P.O.A.D.P. (AMENDED)
LONE STAR BUSINESS PARK
SOUTHEAST CORNER OF IH 10 AND UTSA
CITY OF SAN ANTONIO, BEXAR COUNTY,

DATE OF AMENDMENT: MARCH 11, 2002
REVISED: MAY 20, 2002

P.O.A.D.P. (AMENDED)
LONE STAR BUSINESS PARK
SOUTHEAST CORNER OF IH 10 AND UTSA BLVD.
CITY OF SAN ANTONIO, BEXAR COUNTY, TEXAS

City of San Antonio
Planning Department
Master Development Plan Section
REQUEST FOR REVIEW

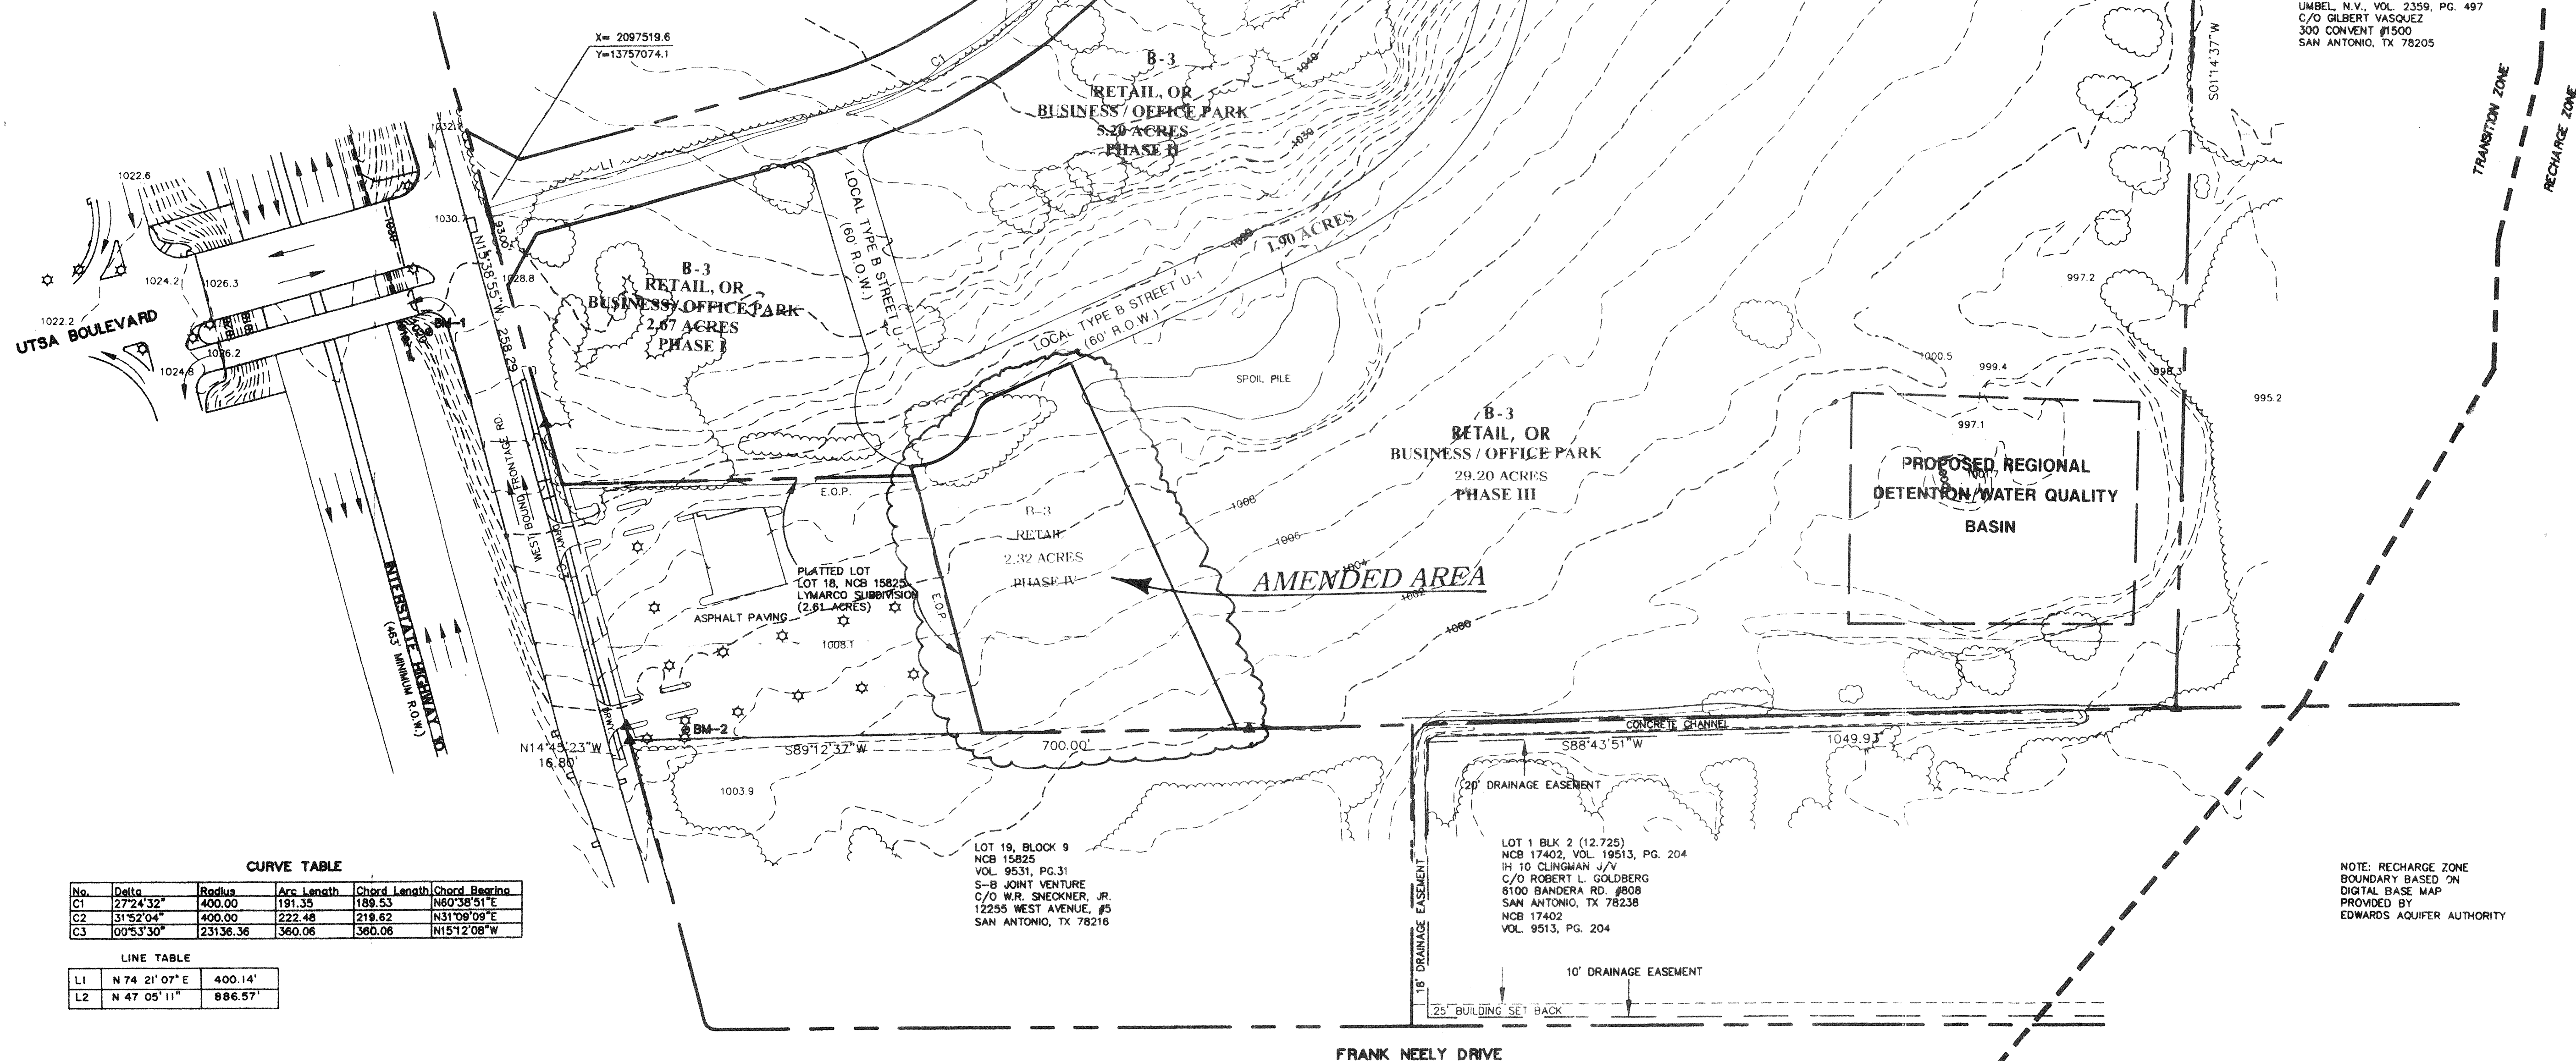
Comments: please attach sidewalk or pedestrian
plan.

Comments: Please provide revised plans to indicate
location of sidewalks and/or a General
Note stating 'Sidewalks shall be installed in the
public right-of-way per UDC requirements'.

This project will comply with the UDC requirements to install a 4'-0" wide concrete pedestrian walk on the public right of way. This new walk will be installed along the property line.

SITE INFORMATION, LOT 18, BLOCK 9, NCB 15825

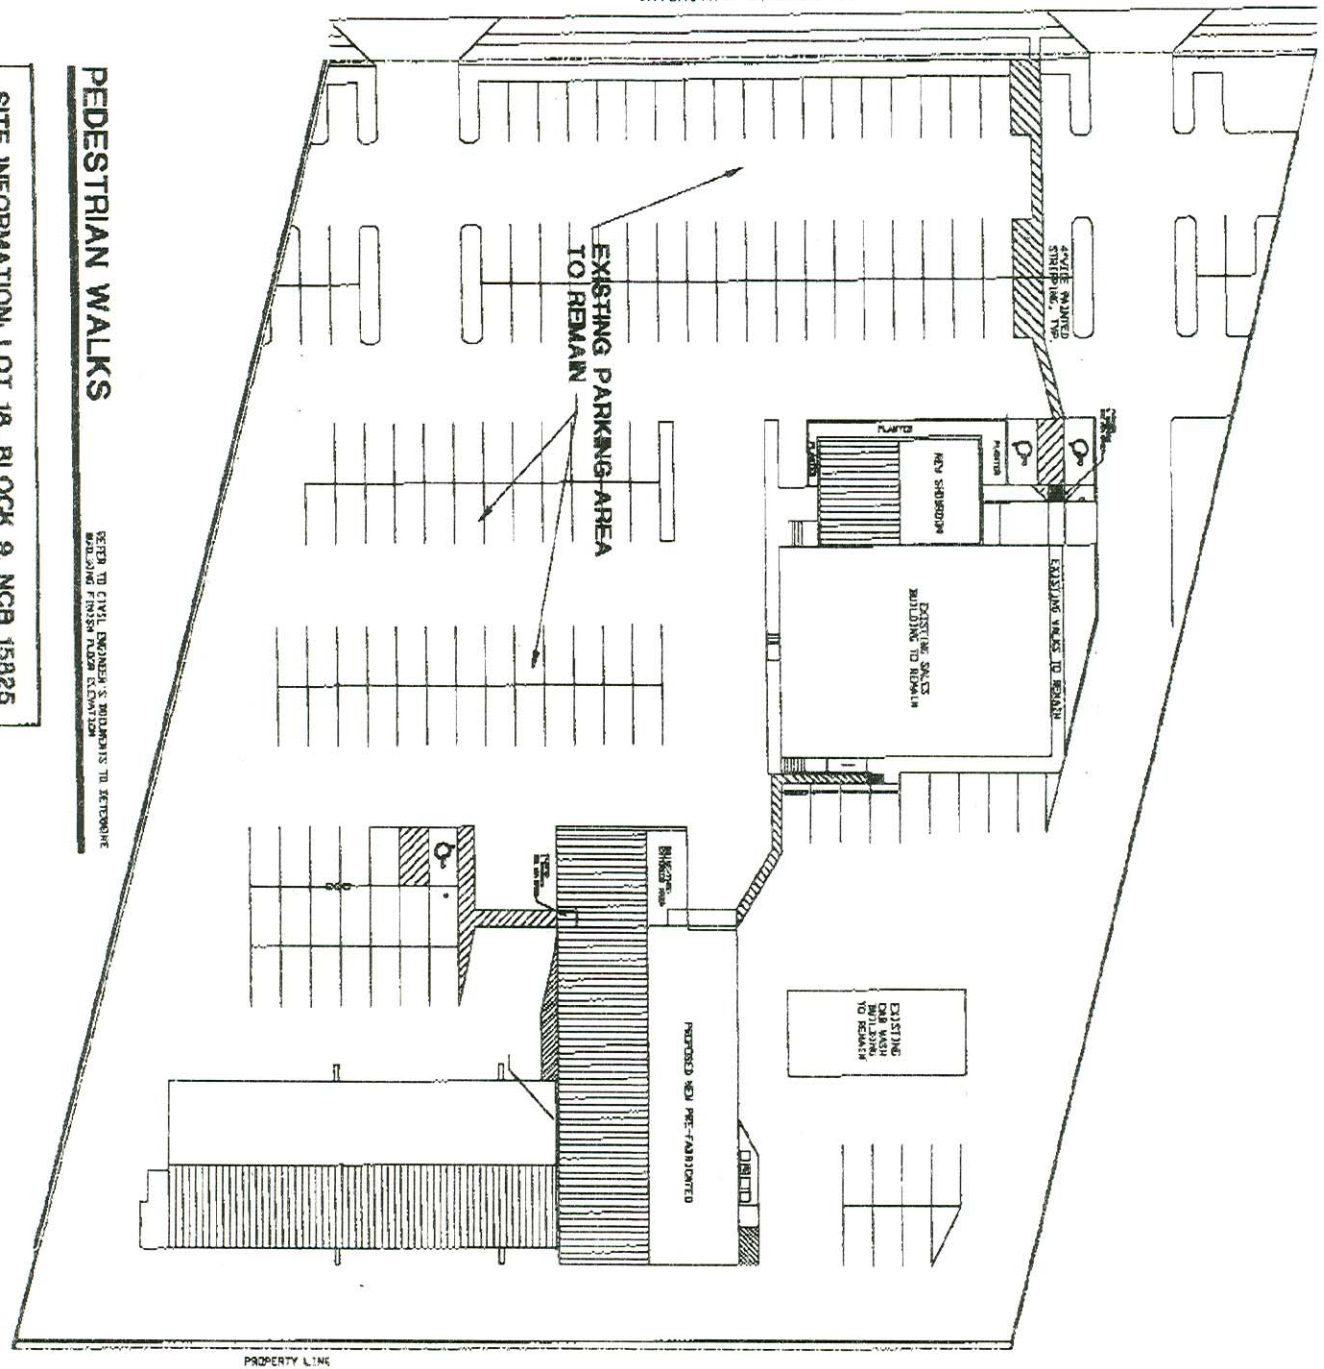
Comments: please attach sidewalk or pedestrian
plan.

SEE TO CIVIL ENGINEER'S DRAWINGS TO DETERMINE
WALKING SURFACE AND WIDTH
